Columbia River CROSSING Comment Form

Preferences for specific alternatives or options, as expressed in comments received before and after the issuance of the DEIS, were shared with local sponsor agencies to inform decision making. Following the close of the 60-day DEIS public comment period in July 2008, the CRC project's six local sponsor agencies selected a replacement I-5 bridge with light rail to Clark College as the project's Locally Preferred Alternative (LPA). These sponsor agencies, which include the Portland City Council, Vancouver City Council, TriMet Board, C-TRAN Board, Metro Council, and RTC Board considered the DEIS analysis, public comment, and a recommendation from the CRC Task Force when voting on the LPA.

Figure 1
HBC plan of Fort Vancouver

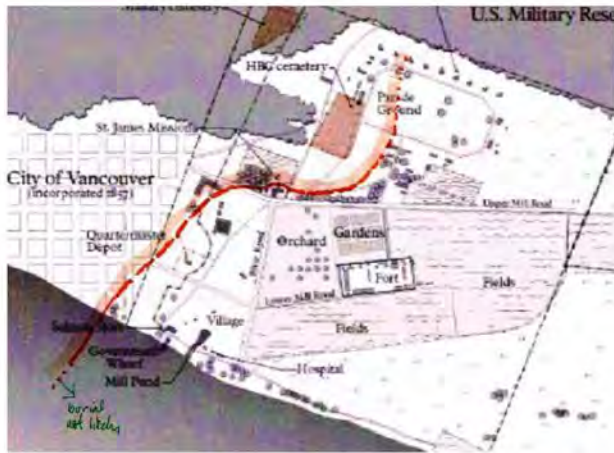
Burials in 'The Village', agricultural areas or the 'Fort' are unlikely. North of Saint James Mission is the cemetery. The orange line is indicative of where informal burials might be found – to the Northwest of the village, mission and fort. Note that the dashed line bisecting the village is the approximate eastern edge of I-5.

Figure 4

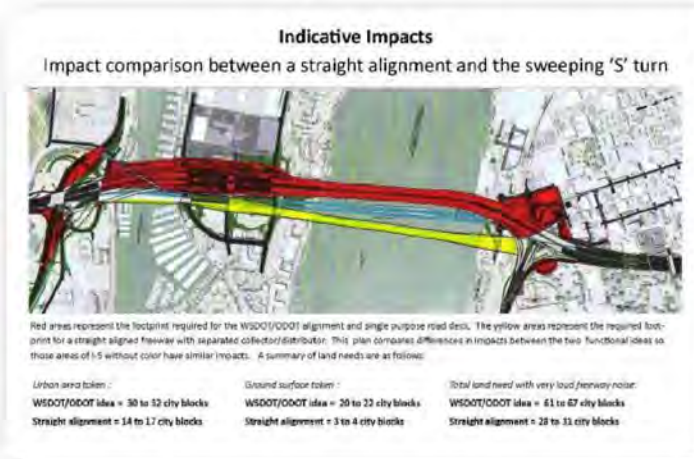
P-029-001 An overview comparison of the two ideas is striking. The following images share these contrasts:

Comparison of CRC downstream alignment with the C-D upstream straight alignment. This is an overall sketch to share the comparative footprint of the C-D Straight Alignment with the CRC curved downstream alignment. Red areas represent land that will be required if the CRC curved downstream alignment is use that is not needed if the C-D Straight Alignment is selected. Yellow is land needed for the C-D Straight Alignment that is not required if the CRC curved downstream alignment is selected. The blue lines are the existing twin I-5 steel truss bridges.

The LPA was determined to provide the best combination of meeting the Purpose and Need, as well as addressing the other evaluation criteria, as summarized in Chapter 2 of the FEIS. Mr. Peterson's idea was reviewed by the Bridge Expert Review Panel who chose not to recommend that CRC pursue it further. It was also reviewed by the CRC staff. The proposal had significant traffic operations deficiencies and did not hold promise that it could perform as well as the LPA or provide any substantial advantages.

Figure 7

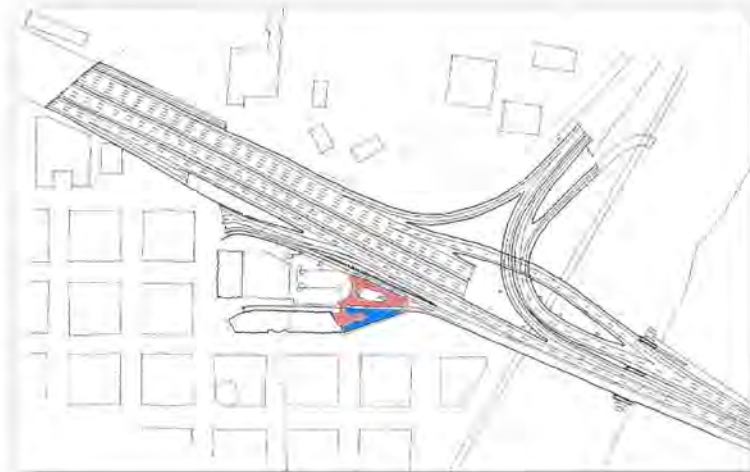
Surface layout showing indicative pedestrian pathways between the park, lower downtown and Columbia River (light brown color). Yellow city blocks are new city blocks that would not be possible with the proposed CRC downstream alignment.
